Amendments to the Drawings:

REMARKS

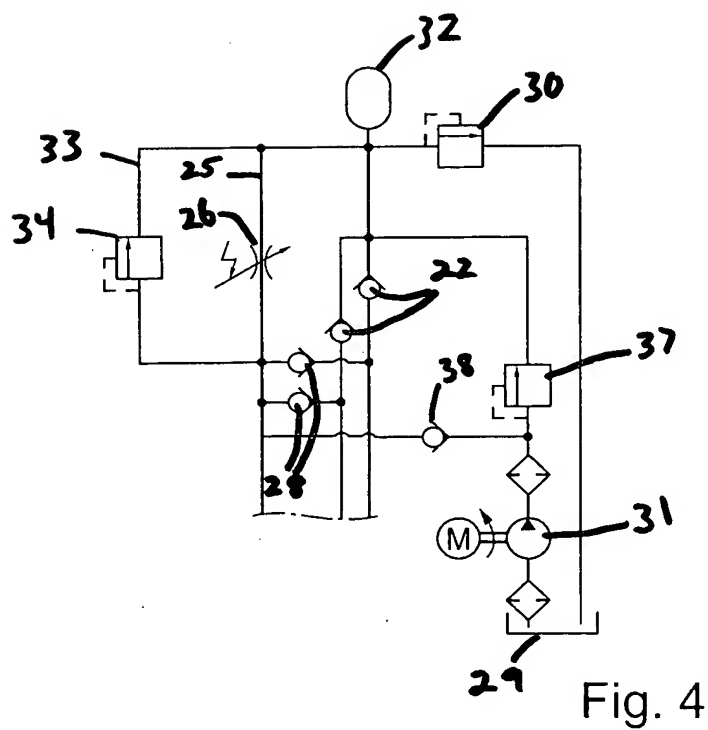
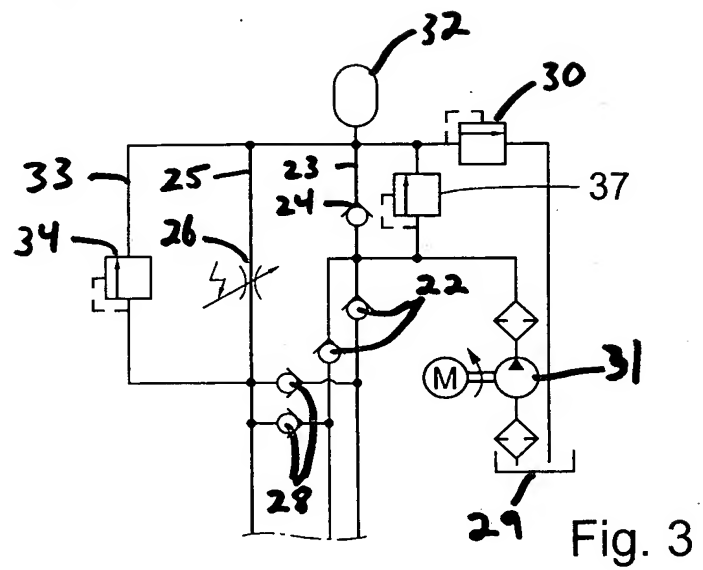
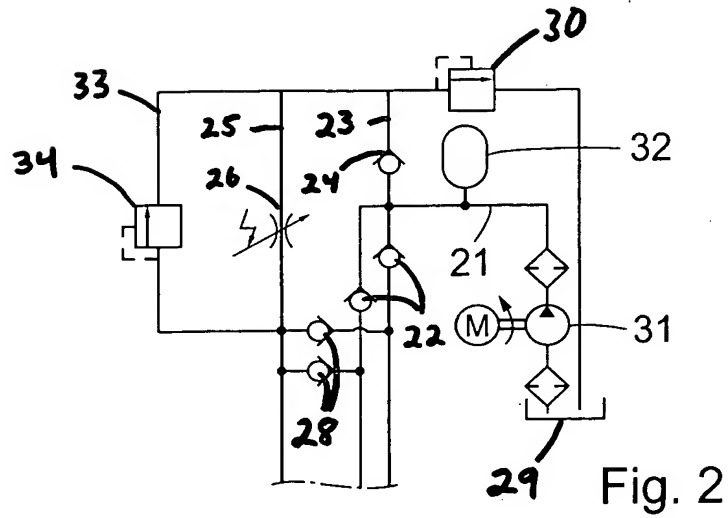
The attached sheets of drawings include changes to Figures 2-4 and 6-10. These sheets, which includes Figures 2-10, replace the original sheets including Figures 2-10. In Figures 2-4 and 6-10, previously omitted reference characters are added.

Figures 2-4 and 6-10 have been objected to as not containing reference characters for all elements shown therein. Figures 2-4 and 6-10 have been amended so as to show reference characters for all elements. Applicant submits that no new matter has been added, as all added reference characters were present in the specification as originally filed and were shown in Figure 1 and/or Figure 5 as originally filed.
